**SUBJECT: Waldorf School site plan application**

**TO: Planning and Development Committee**

Report Number: PB-66-19

**DATE: Tuesday, September 17, 2019**  
**APPLICATION NAME: 2254 Orchard Road - Halton Waldorf School**  
**ADDRESS: 2254 Orchard Rd.**  
**FILE: 535-002/19**

endix B – Site Plan

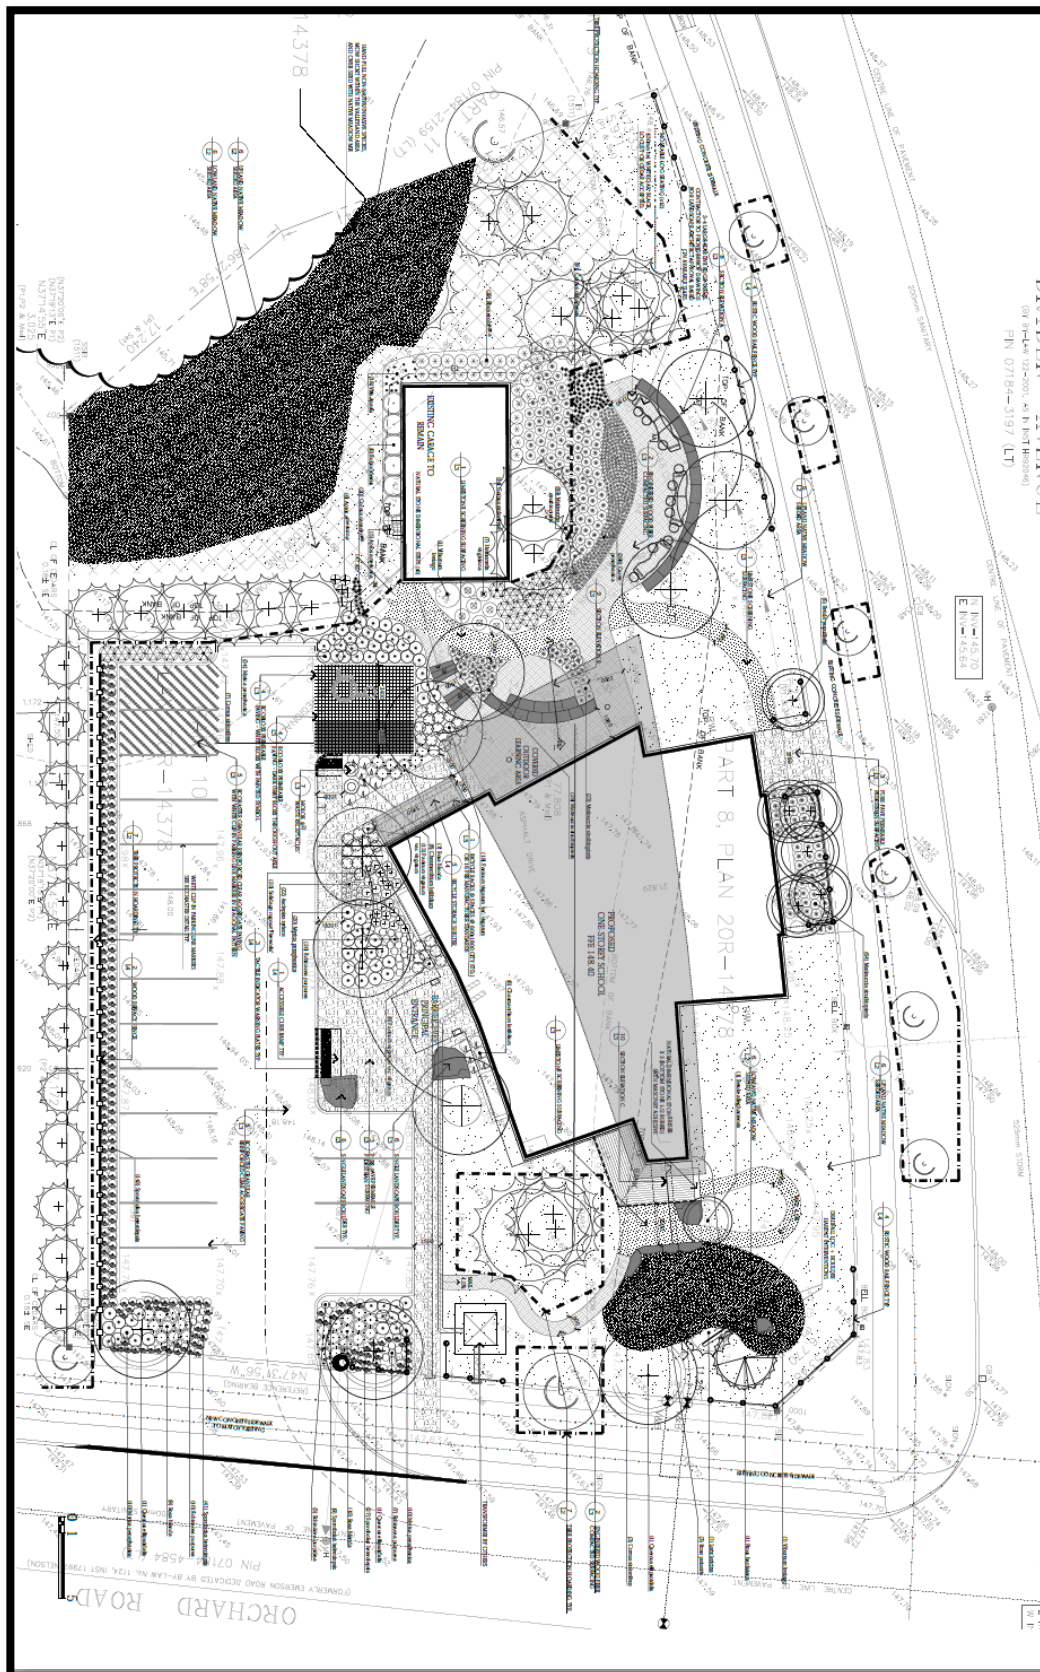
It should be noted that the proposed site plan shows future 1 storey additions to the school building. These additions are not included in this site plan application and do not form part of this recommendation for site plan approval. Additional planning approvals will be required should the school wish to proceed with these additions.

- 3.1. Applicant has indicated that the window well along Dryden Avenue will not be attached to the building. Applicant to provide details as well as, modify the basement floor plan as it suggests that the window well is part of the foundation and not unattached.
- 3.2. Apply for a Zoning / Grading and Drainage Clearance Certificate.
- 3.3. Submit a completed Non-residential Development Charges Information Form.
